Comments received on withdre	awn Application

RE: EXPANSION OF LIQUID OXYGEN AND DIESEL STORAGE AT THE AIR PRODUCTS FACILITY LOCATED WITHIN THE COEGA SPECIAL ECONOMIC ZONE, PORT ELIZABETH, EASTERN CAPE PROVINCE

PROVINCIAL REGISTRATION NUMBER: ECm1/C/LN1/M/40-2019

The effects of a 23m3 diesel tank on a Food Manufacturing Facility

Figure 3. The effects of diesel quality on emission generation represented by centane number of diesels. The centane number is represented on the x-axis whilst the emissions in g/kmh are represented by the y-axis as in figure 1 [1].

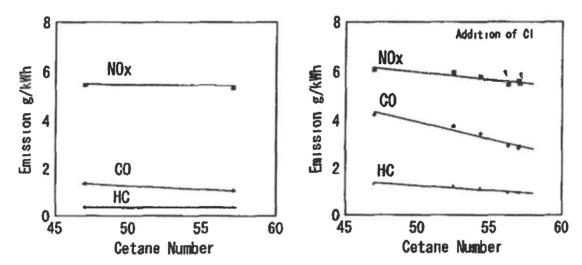
We would like to raise the following concerns regarding this project. If our understanding of the project is incorrect, we would welcome additional information and cordial communication between our business ventures to address this miscommunication or misunderstandings. The initiator intends to use the 23m3 tank as a fuel point for trucks. These trucks would emit high concentrations of exhaust emissions into the surrounding area. This area is located less than 50m away from our raw material collection point. It has been noted that exhaust smoke from diesel engines introduce unburned hydrocarbons, carbon monoxide, sulphur dioxide, nitrogen oxide and particulate matter into the atmosphere [1]. Carbon monoxide is of concern due to its effect on biological systems. Additionally, it has been acknowledged that the age of the engine plays a major role in the degree of pollution with older models introducing higher quantities of such gasses. Likewise, the quality of the diesel also effects these emissions with low centane diesel facilitating higher emissions (Fig 1 - 3).

These factors would have to be considered from a food safety perspective as these emissions are harmful to food products. Additionally, under the South African National Standard 10131:2004 subsection 4.2.2 "Location of above-ground tankage" [2] it states that, cognizance shall be taken of population densities around the premises and good housekeeping such as the removal of flammable materials such as rubbish, dry vegetables and oil-soaked soil. Additionally, it states under subsection 4.3.1 "General tankage layout – minimum safety distances" that safety distance is based upon the class of liquid. Diesel is classified as a class II liquid, therefore the minimum safety distance from a boundary of an adjacent property is 3m. The proposed location of the diesel tanks (Fig 4) lies close to our boundary fence. Furthermore, since we are a food manufacturing facility specialising in fruits and vegetables such dried matter can occasionally be found along our boundary fence. Additionally, the area directly adjacent to the proposed location houses our old equipment and storage bins. This old factory equipment could contain reflective material possibly able to generate heat while the bins contain rubbish, which may be ignited. Fires started by reflective metals or glass have had devastating effects and their ability to start fires has been studied for many years [3].

Figure 5. Percentage of time from which wind direction spent in a direction during 2018 within Coega.

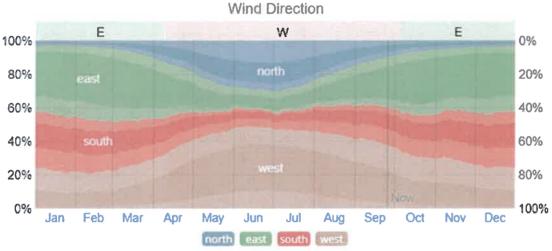
From an operational healthy and safety aspect, some of our maintenance and raw material personnel frequently operate in this area. As stated in the Major Hazard Installation report, the tank was not to be placed near the guard house on the initiator's premises due to the presence of the building and personnel. We would like if this courtesy were extended to encompass our own personnel who work in the area. The Major Hazard Installation report also reflects that wind is likely to blow vapours in the direction of the bulk cryogenic storage facility, however, this appears to be unlikely. Data gathered from two differing sources (Fig 5 [4] and 6 [5]) indicate that, for most of the year, wind direction maintains a South to South West consistency. Our storage facility and collection point lie at South-West: 202° whilst our location for storage of old equipment lies at South: 207°.

Diesel vapour is another concern to us, as our own standard (ISO22002-1) states that diesel powered forklifts shall not be operated within a food storage facility. Although not necessarily within our facility it should also be noted that diesel vapour has a density greater than that of air [6]. The location is completely paved on both sides and light winds could potentially dissipate diesel vapour into our own warehouse depending on the amount of vapour produced during refuelling of trucks or during a leak of the diesel tank.
